Technical Bulletin 168

05.2016

Contents

Item: 168.13

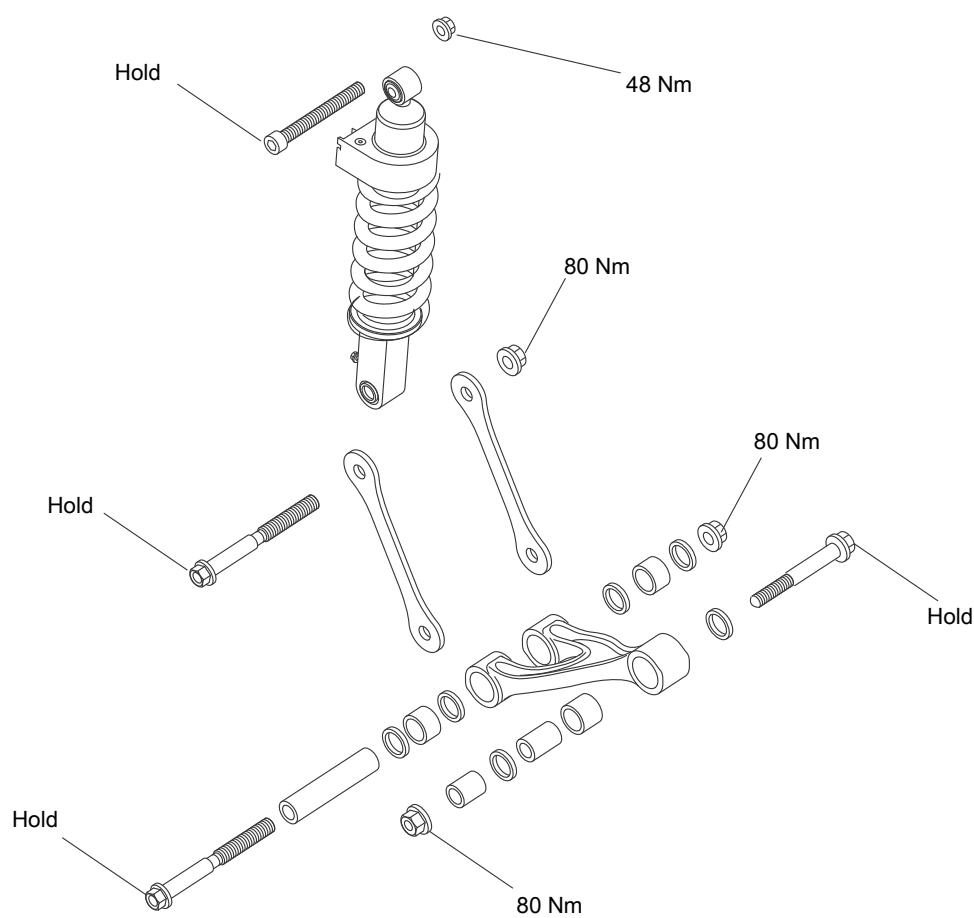
When installing the rear suspension drag link and drop links, follow the procedure described in the Service Manual noting the following tightening sequence:

- When tightening the drag link and drop link fixings, hold the bolts to prevent rotation, while tightening the nuts to **80 Nm**.

Item: 168.14

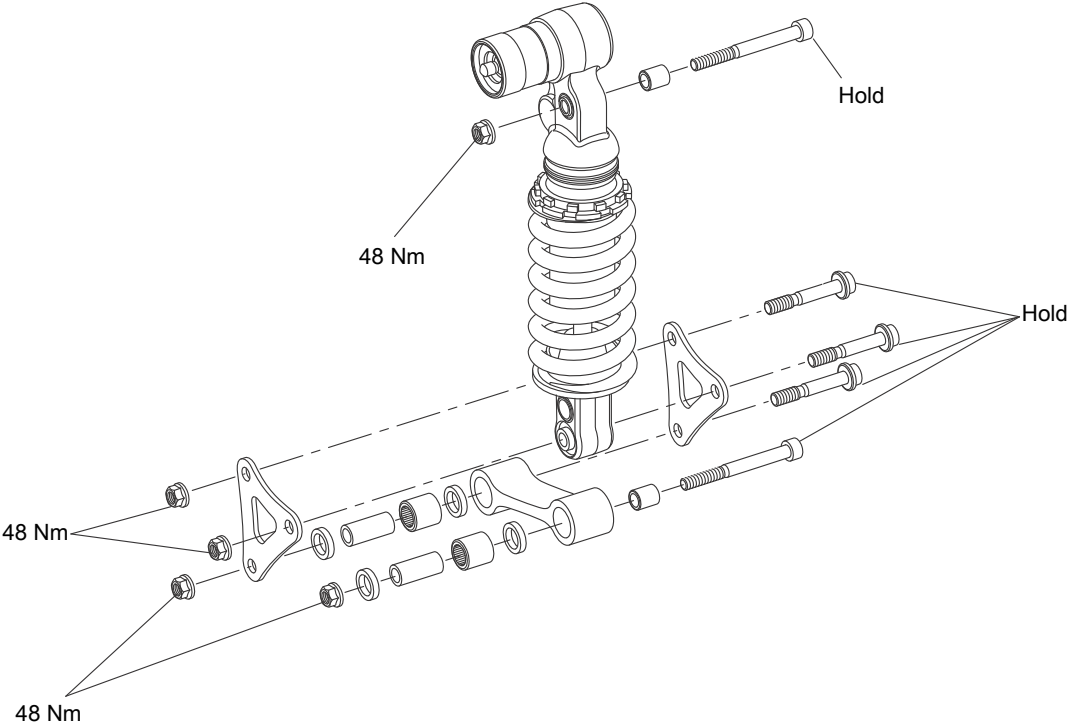
When installing the rear suspension drag link and drop links, follow the procedure described in the Service Manual noting the following tightening sequence:

- When tightening the drag link and drop link fixings, hold the bolts to prevent rotation, while tightening the nuts to **48 Nm**.

Item: 168.15
Description: Headlight Rim Fixings
Model Affected: America, Speedmaster

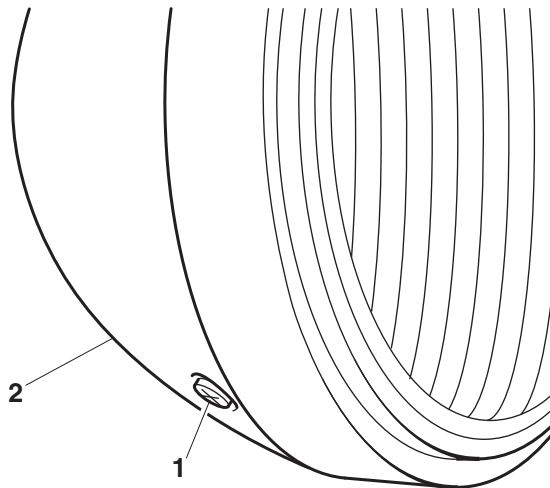
The torque figure for both of the headlight rim fixings has changed to **2 Nm** on the above models.

- **Models already in service need not be re-tightened unless the fixings have been loosened or removed.**

Item: 168.16

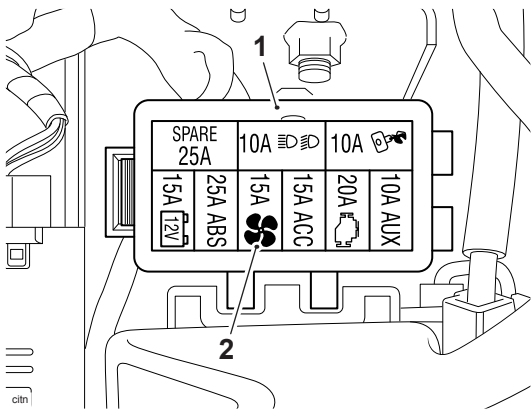
The fuse protecting the cooling circuit has been increased to 15 amps. If for any reason the original 10 amp cooling fan fuse fails, it must be replaced with a 15 amp fuse and the label on the fuse box changed to reflect the new fuse rating.

- 1. Fuse box
- 2. Cooling fan fuse

Item: 168.17

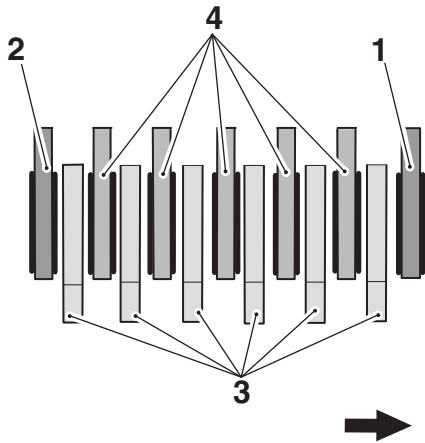
Technical News issue 125 Item 9 Clutch Pack Height, indicates that the six steel plates are 1.4 mm thick. The correct thickness for the steel plates is 2.0 mm, therefore Technical News 125 and the clutch section of the service manual must be amended to reflect this. The clutch pack height should only be measured if any of the friction plates or steel plates have been replaced. If building a new clutch pack its height must be correct. To achieve this, build the new clutch pack with the following:

- 1 x new outer friction plate;
- 5 x new friction plates;
- 1 x new inner friction plate;
- 6 x steel plates, 2.0 mm thick.

Standard height in mm	Tolerance in mm
35.10	+0.31 / -0.62

Item: 168.19

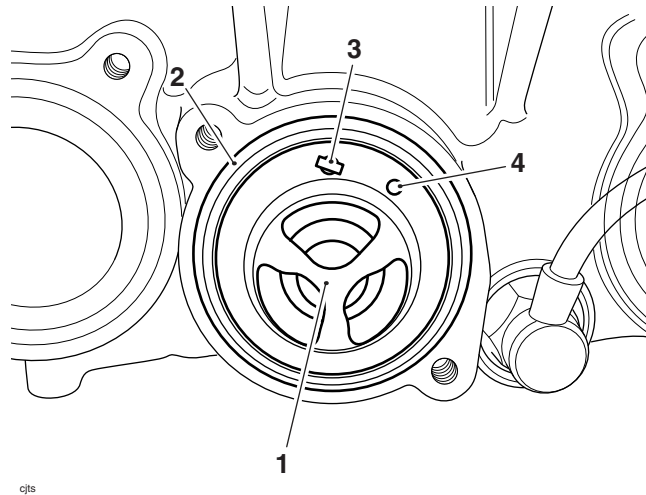
A revised thermostat is now in use and is retrofittable from engine number 422367.

The revised thermostat utilises a jiggle pin and an air bleed hole. The jiggle pin allows trapped air in the cooling system to pass through the thermostat into the radiator and is then dispersed via the coolant expansion tank.

If the thermostat is removed or replaced for any reason it must be refitted with the jiggle pin positioned towards the top of the cylinder head as shown.
